COUNCIL ASSESSMENT REPORT

Panel Reference	PPS-2017STH009
DA Number	RA17/1000
LGA	Shoalhaven City Council
Proposed Development	Concept masterplan for a mixed-use development (comprising of residential flat buildings, commercial premises and shop top housing) and associated minor boundary adjustment subdivision
Street Address	Anson Street, St Georges Basin
Applicant/Owner	Eastern Grey Developments Pty Ltd / David DeBattista
Date of DA lodgement	30 March 2017
Total number of Submissions Number of Unique Objections	Council received 250 submissions objecting to DA in 2017 and 83 submissions objecting to the amended DA in 2020 when the amended proposal was renotified as part of the LEC Court proceedings.
Recommendation	Refusal
Regional Development Criteria (Schedule 6 of the SEPP (Planning Systems) 2021	General development over \$30 million: Development that has a capital investment value of more than \$30 million.
List of all relevant s4.15(1)(a) matters	<ul style="list-style-type: none"> • State Environmental Planning Policy (Biodiversity and Conservation) 2021; • State Environmental Planning Policy (Planning Systems) 2021; • State Environmental Planning Policy (Resilience and Hazards

Figure 29. Excerpt of 3D View with shadow analysis plan [M05D] - Northern side of Anson Street at 11am and 3pm

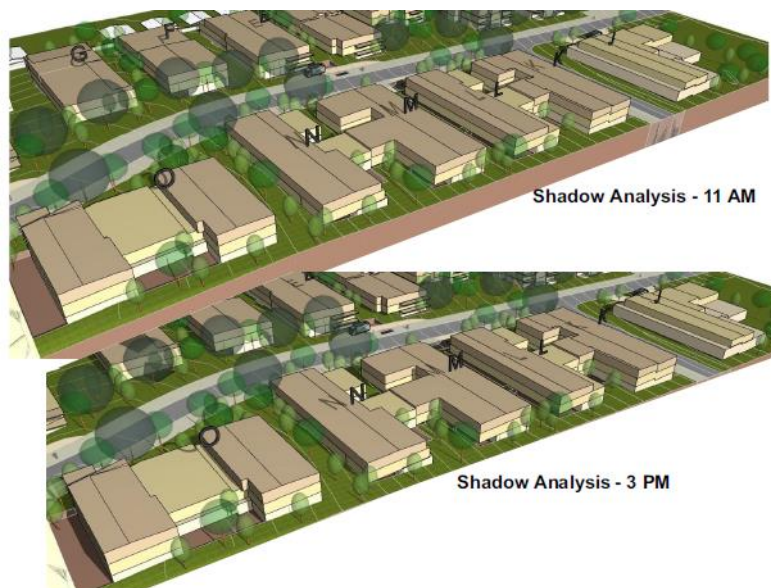
*“The Shadow Analysis [M04D and M05D] technique (e.g. **Figure 29**) is unclear and does not assist in the assessment of building amenity. ‘View from the sun’ diagrams should be provided at half hour intervals.*

The public domain and neighbouring development should be included in the diagrams, particularly the site to the south. (m) The Shadow Diagrams [M06D to M09D] show that proposed Buildings J, K, L, M, N and O overshadow the northern footpath of Anson Street (SDCP2014 N23 5.2 A5.1). This is not consistent with minimising shadowing of publicly accessible open spaces (SDCP2014 N23 5.2 A4.1)”

Figure 37. Building L and K cross-section plan [Shoba Designs, M03D, 17/7/2020]

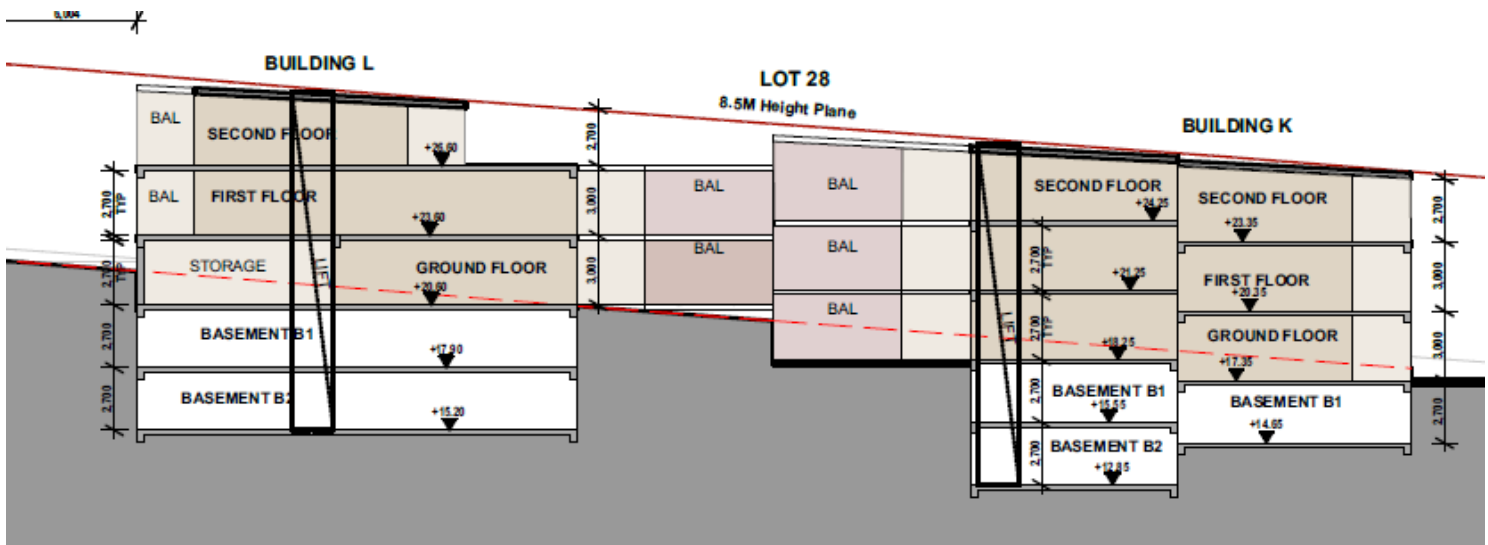
The Apartment Design Guide (ADG) Design Criteria 2C-1 1 and ADG Figure 4C.5 specifies a floor-to-floor height of 3.1m is required to achieve the required floor-to-ceiling height of 2.7m (ADG 4C-1 1). Floor-to-floor heights of 3m are insufficient to fit the required services bulkhead for a residential flat building, and reduced floor to ceiling height results in reduced and unacceptable amenity for future apartments.

Numerous buildings are shown on the Sections and Elevations Plan [M03D] to 'touch' the height plane as shown in the example at **Figure 37**. Three sections are provided on the Sections and Elevations Plan [M03D], which over a development of this scale and site area is insufficient to give an accurate representation of the actual heights of the buildings given the minimal margin for error. Additionally, lift overruns are not indicated and are likely to further increase overall building heights, and the roof of Building J for instance touches the 8m height limit, with no allowance for lift overruns. It is likely the lift overrun will exceed the maximum height control.

Figure 40. Building Envelope Plan of Buildings G, H and I [M02, Rev D] identifying setbacks between buildings that have not been adequately addressed.

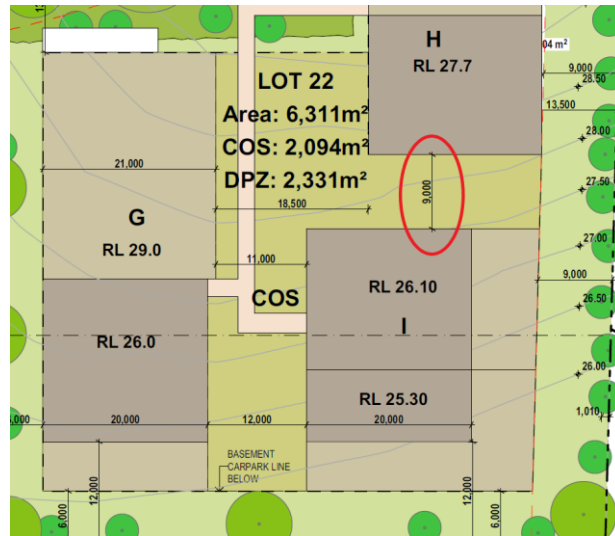
<p>3F-1 Visual Privacy</p> <p><i>Adequate building separation distances are shared equitably between neighbouring sites, to achieve reasonable levels of external and internal visual privacy.</i></p>	<p>Setbacks under this control for up to 4 storeys require 6m between habitable rooms and balconies and 3m between habitable rooms. A note is included in this Design Criteria stating <i>Note: Separation distances between buildings on the same site should combine required building separations depending on the type of room (see figure 3F.2 – reproduced at Figure 39).</i></p>	<p>No</p>
<p><i>Separation between windows and balconies is provided to ensure visual privacy is achieved. Minimum required separation distances from buildings to the side and rear boundaries are as follows (for building heights up to 12m):</i></p> <ul style="list-style-type: none"> – <i>Habitable rooms and balconies: 6m</i> – <i>Non-habitable rooms: 3m</i> <p><i>Note: Apartment buildings should have an increased separation distance of 3m (in addition to the requirements set out in design criteria 1) when adjacent to a different zone that permits lower density residential development to provide for a transition in scale and increased landscaping (figure 3F.5)</i></p>	<p>While the building envelopes are generally compliant, the uses of the adjoining units e.g. habitable or non-habitable rooms, is unknown as the 'proof-of-concept' plans are not able to be reconciled with the proposed masterplan layout. For instance the separation between Building H and I is 9m. This would assume that one building has non-habitable uses facing the other building while habitable rooms could be within the other building.</p> <p>Without adequate 'proof-of-concept' plans being provided, the ability for a future DA to comply with this, and not require variations or future modifications cannot be assessed.</p>
